March 24, 2014

NOTICE OF ADDENDUM
ADDENDUM NO. 1
CONTRACT NO. 7206

STATE STREET RECONSTRUCTION
ASSESSMENT DISTRICT 2014

1 PARK STREET GRANITE PAVER FADE PATTERN
P7 3/8"=1'-0"

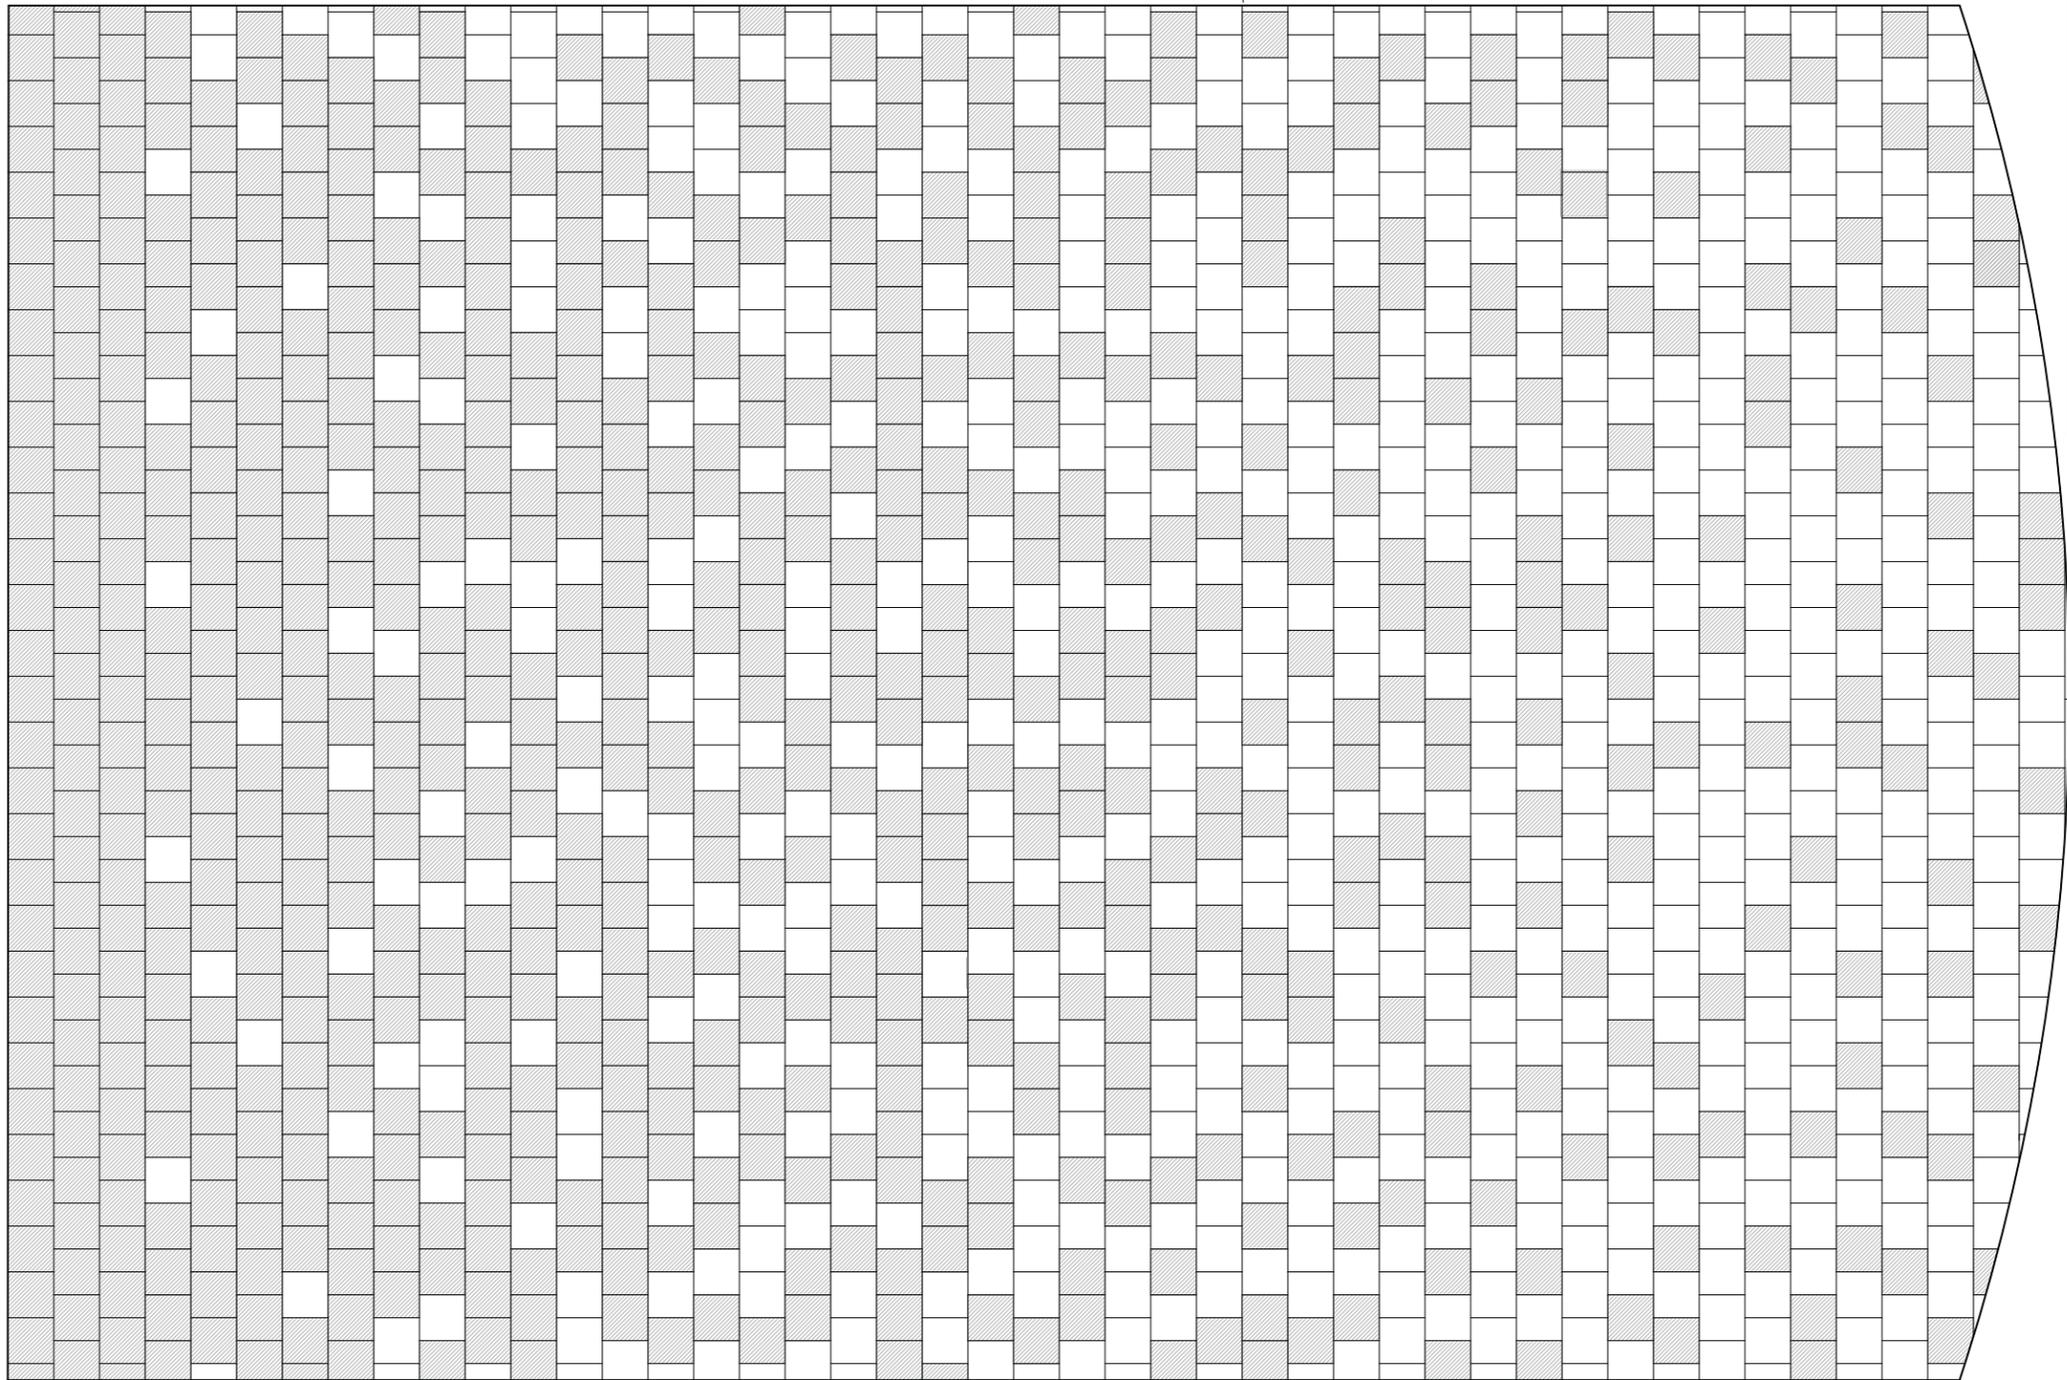
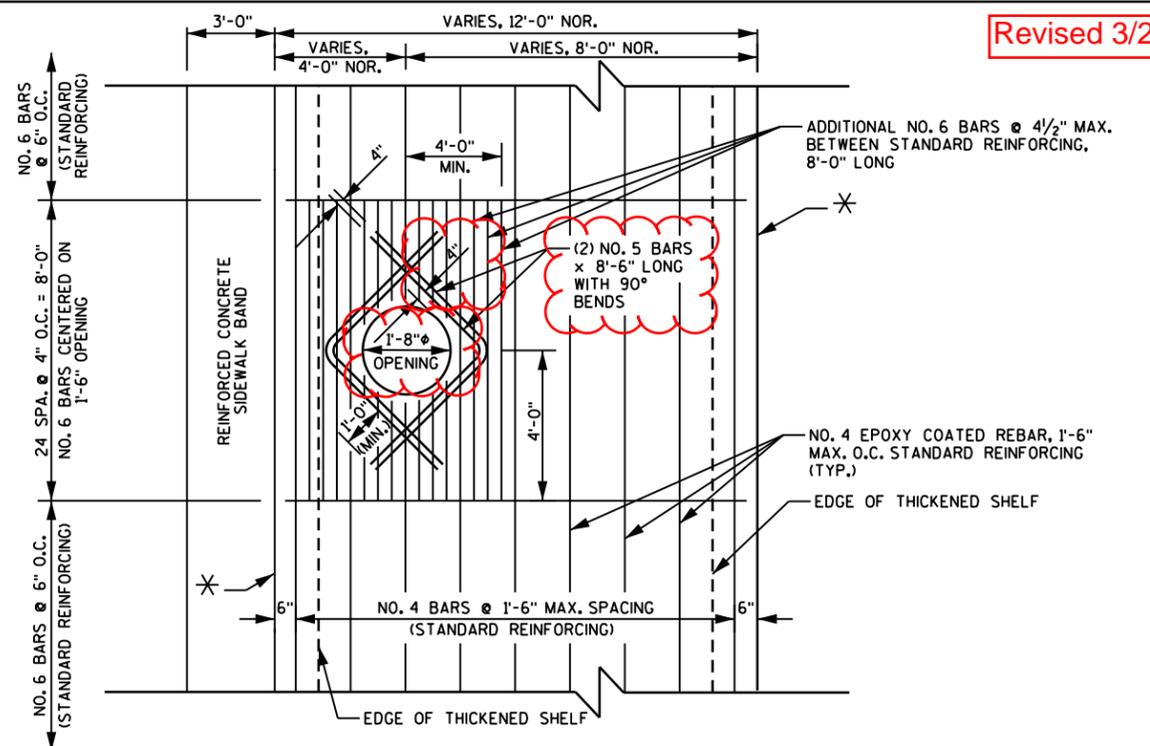
Replace Sheet P7 (Revised 3/18/14) – Updated granite paver pattern detail.

Revised 3/18/14 - Updated Pattern

REINFORCEMENT PLAN - PEDESTRIAN LIGHT BASE OPENINGS

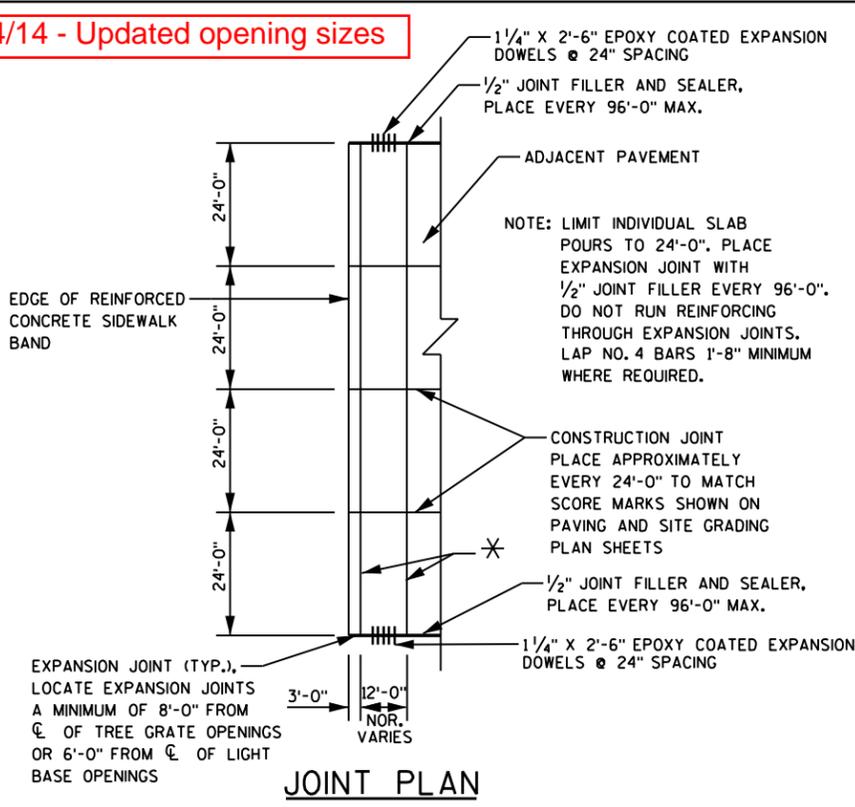
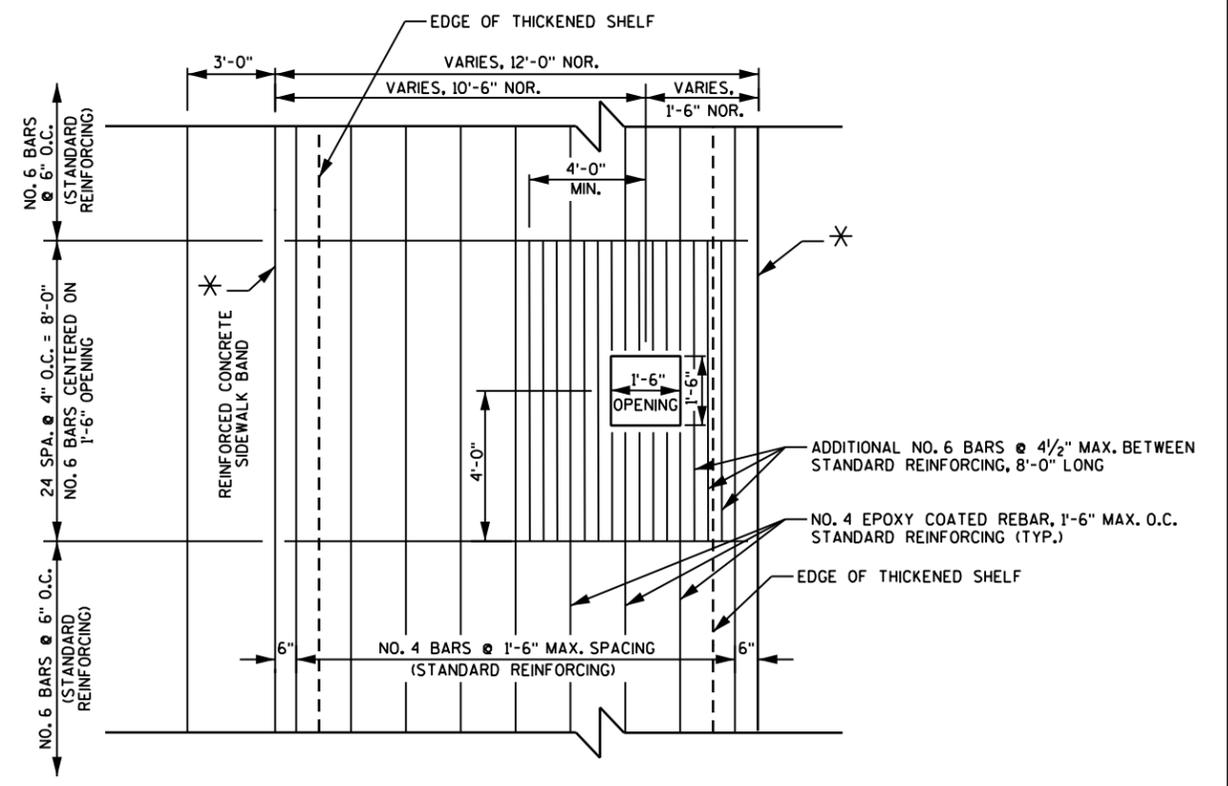
Replace Sheet P8 (Revised 3/24/14) – Updated opening size for pedestrian light and tree grate in tree pit slab.

Revised 3/24/14 - Updated opening sizes

SITE GRADING PLAN
STATE STREET CITY OF MADISON

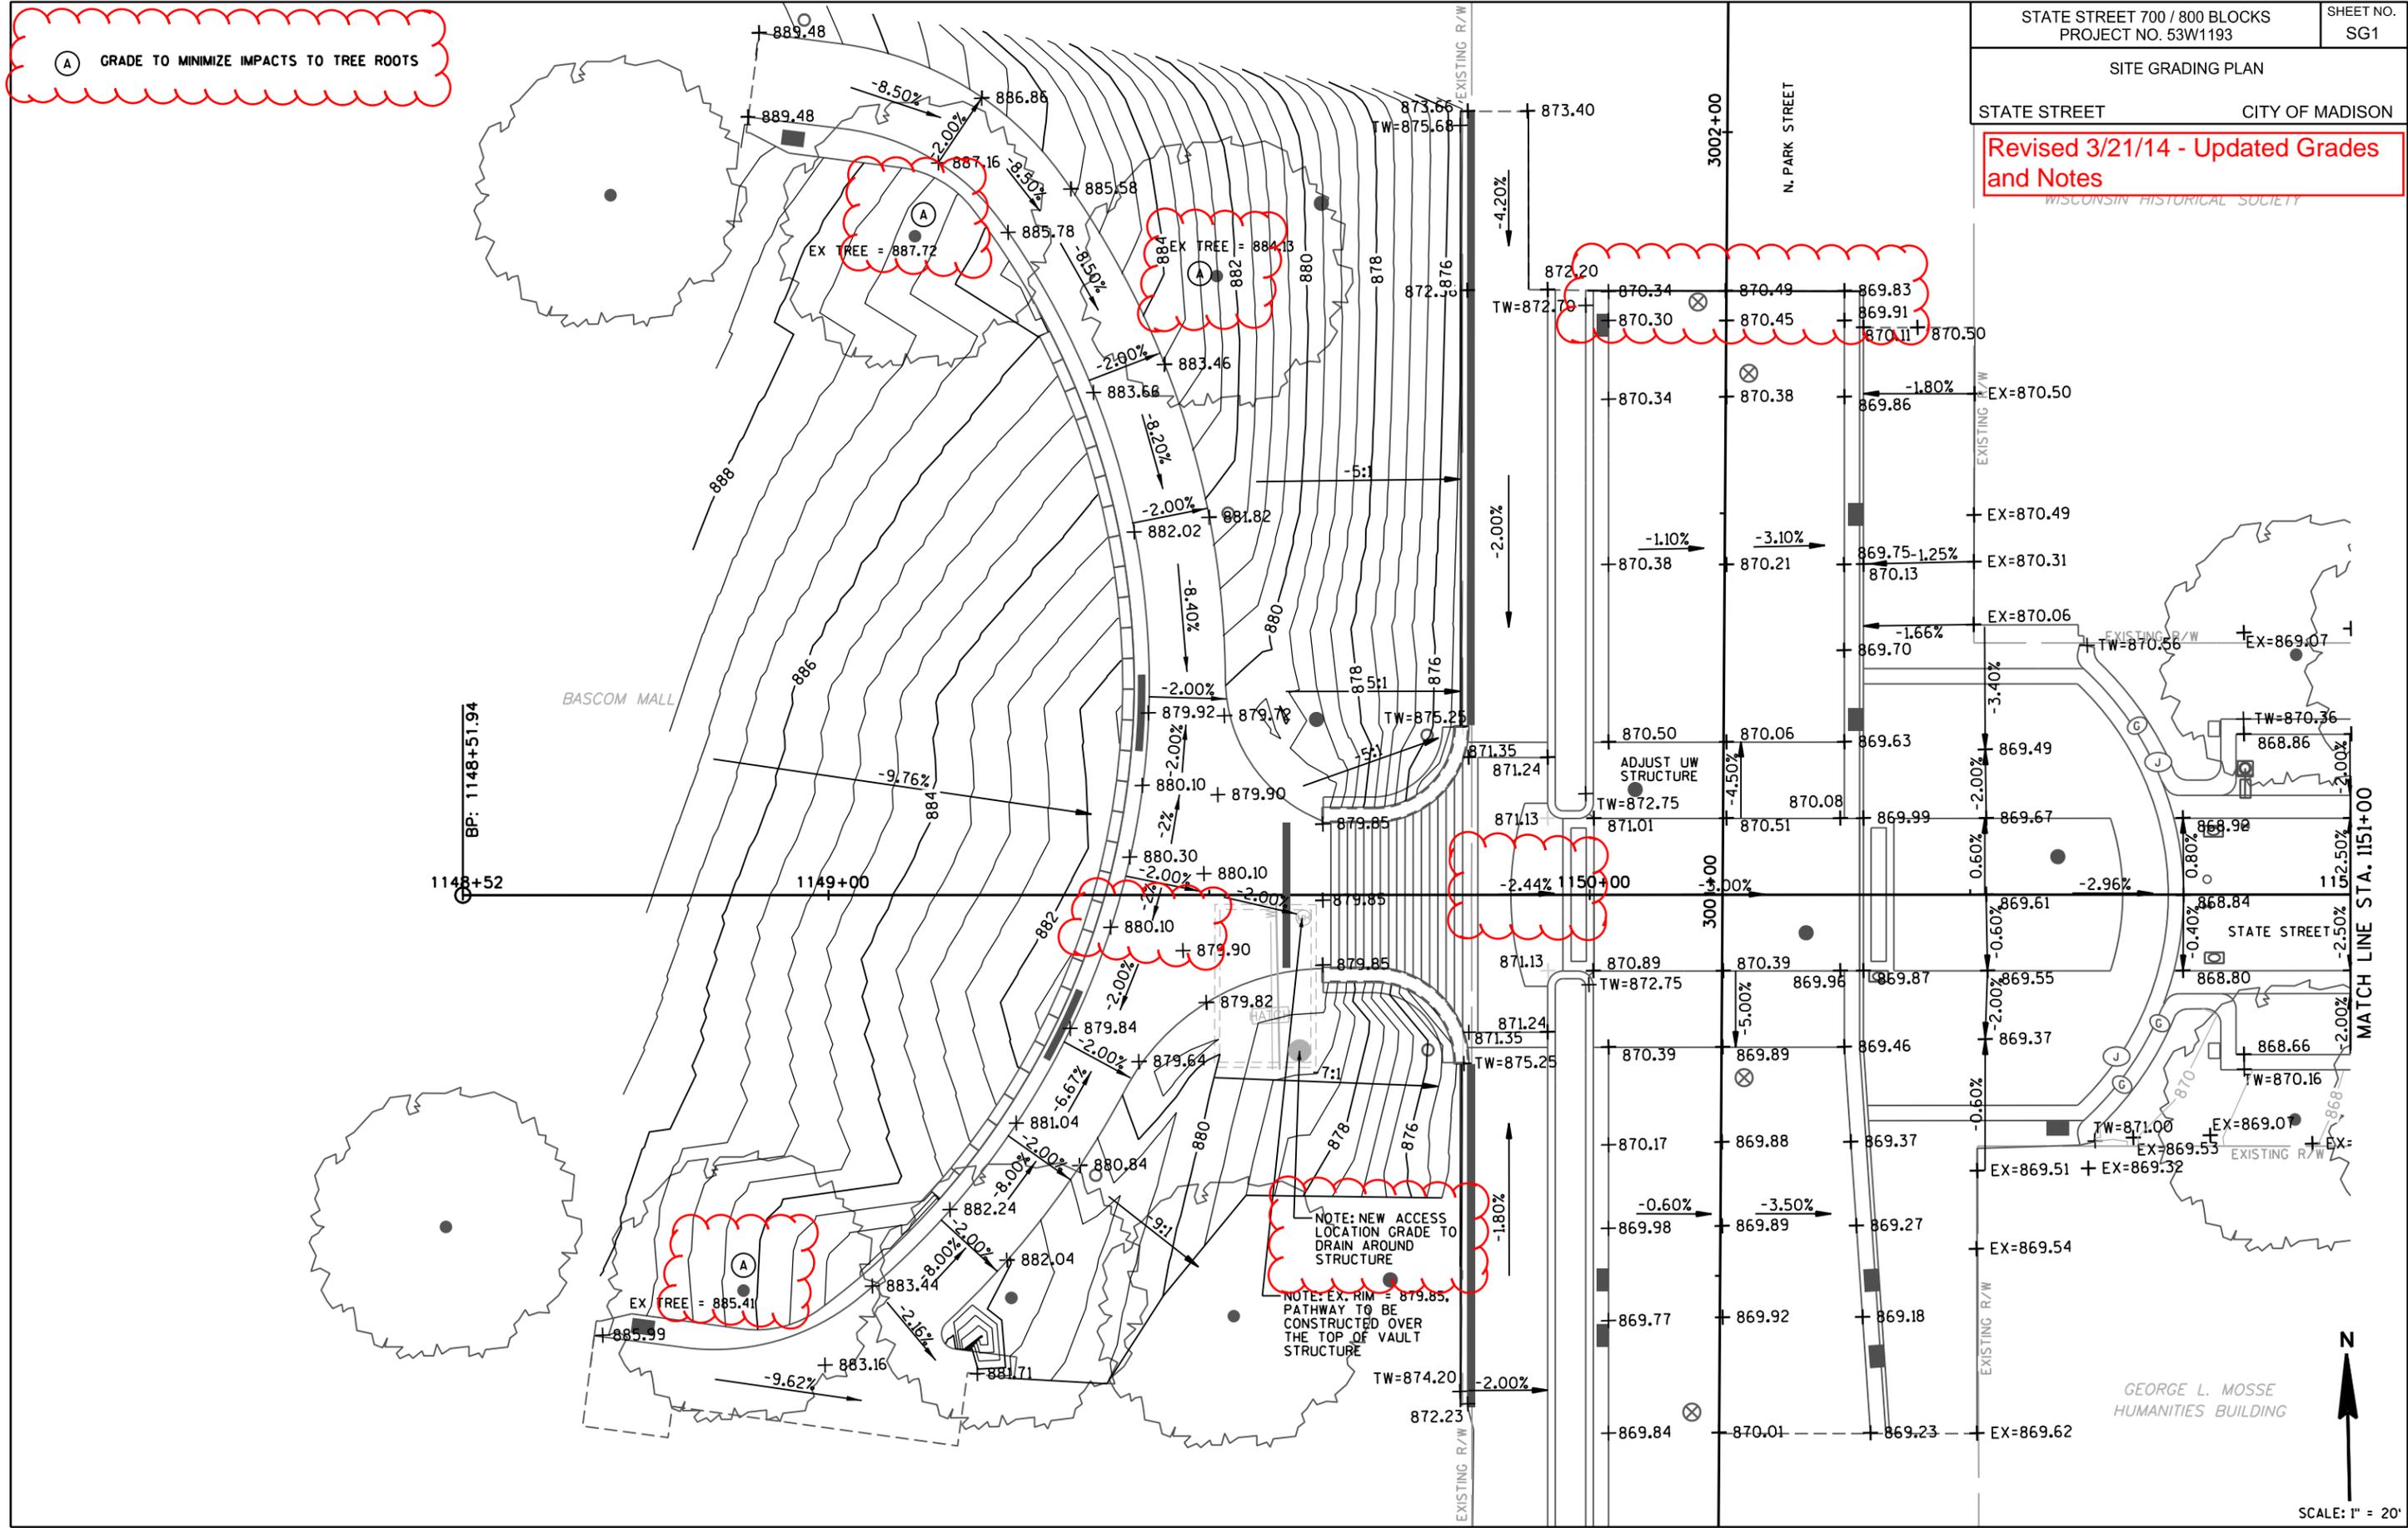
Replace Sheet SG1 (Revised 3/21/14) – Updated grades & added notes for tree protection & water meter pit access relocation.

Revised 3/21/14 - Updated Grades and Notes
WISCONSIN HISTORICAL SOCIETY

NOTE: NEW ACCESS LOCATION GRADE TO DRAIN AROUND STRUCTURE
NOTE: EX. RIM = 879.85. PATHWAY TO BE CONSTRUCTED OVER THE TOP OF VAULT STRUCTURE
